Response to R1

R1 general comments

Response to R2

Figure 1: Tephra loading contours according to FALL3D version v7.3 (solid red line) and version v8.0 (solid black line). The new version v8.0 shows a less diffusive distribution.

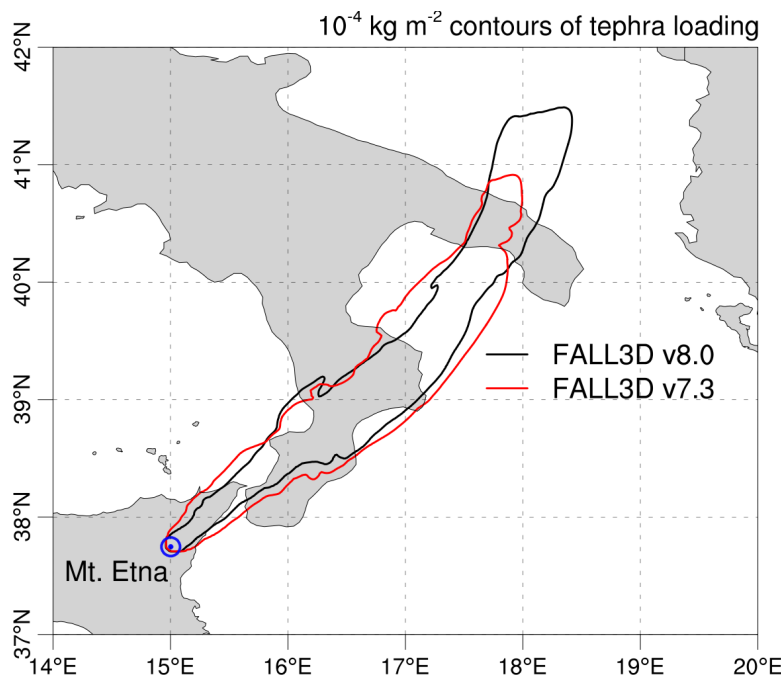
10. The Poret 2018 paper is a very detailed study of this Etna eruption using FALL3D and so I am struggling to see what its inclusion in this paper brings. It has already been demonstrated that FALL3D can be applied to this sort of study. This could have been a very good opportunity to compare v8 of the model against a previous study, but this is not done. The main difference appears to be the use of much higher resolution meteorology, which is an input to the model, not the model itself. Is this the reason why the agreement between the model and obs appears (at least at face value from the log graphs in both papers) to be better in this paper? Much more detail on the reason for the differences is needed and to justify the inclusion of this case-study in this paper.

The main differences between our study and Poret et al. (2018) are: (i) the horizontal resolution of both met data and dispersal model, (ii) the vertical coordinate system, (iii) the Total Grain Size Distribution (TGSD) used to define the source term, and (iv) the dry deposition parameterization. Numerical diffusion errors are reduced here because we performed higher resolution than Poret et al. (2018), which is manifested in an ash loading field extended over a larger area in Poret (2018) (compare Fig. 14 in our work to Fig. 6 in Poret et al., 2018). To show this we performed a new simulation of the Etna eruption using a previous version of FALL3D (version v7.3). To make fair comparisons, the horizontal resolution (0.015°), the number of vertical levels (60), and the TGSD were set to be consistent with the simulations performed with FALL3D v8.0. Results are shown in Fig. 1 and Fig. 2 below. Figure 1 compares the $10E-4 \text{ kg/m}^2$ contours of tephra loading according to version v7.3 (solid red line) and version v8.0 (solid black line). The new version v8.0 tends to have less numerical diffusion.

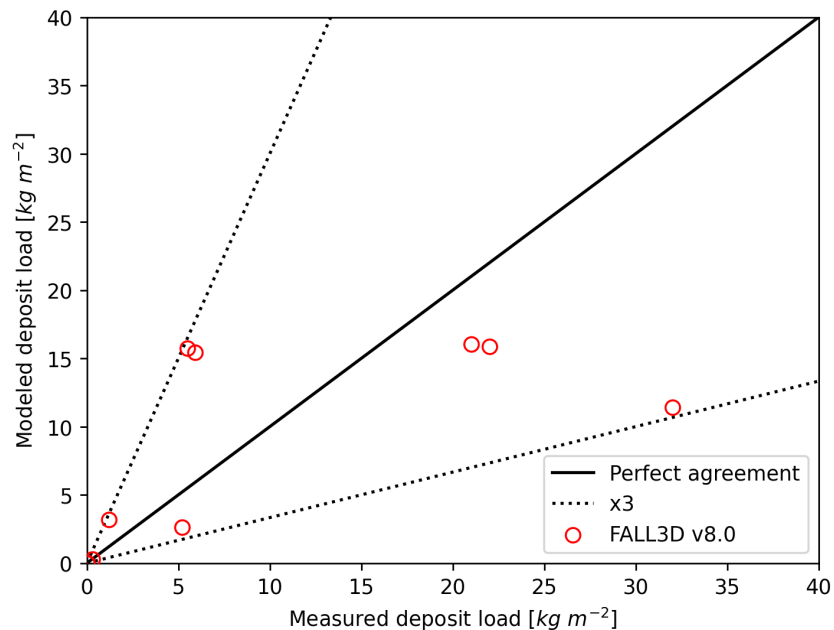
Line 393: “all points lie within a factor of 3 error band” - A factor of 2 would be the more conventional choice of statistic here. I suspect that the log scale is rather deceptive for the lack of agreement at the larger values! And it is the larger values that have the bigger impact and so are more important to get correct. It would be good to see this part of the graph on a linear scale if possible.

All points lie within the 1:3 ratio band and the factor 3 seems to be more significant. Not all points are within the 1:2 band. So, we see no reason to change this figure. We provide below the linear scale version of this figure, but it is not included in the manuscript:

Note that proximal sampling sites S1-S5, associated with the highest values of deposit load, are located <10 km from the vent. For this paper, the horizontal resolution was 0.015° (~ 2 km). As a result, extremely high resolution should be carried out to capture variations of tephra loading measured from proximal samples and large errors are expected in this case. For this reason, we prefer to emphasize results related to distal and medial sites (S5-S10) by using a log scale.
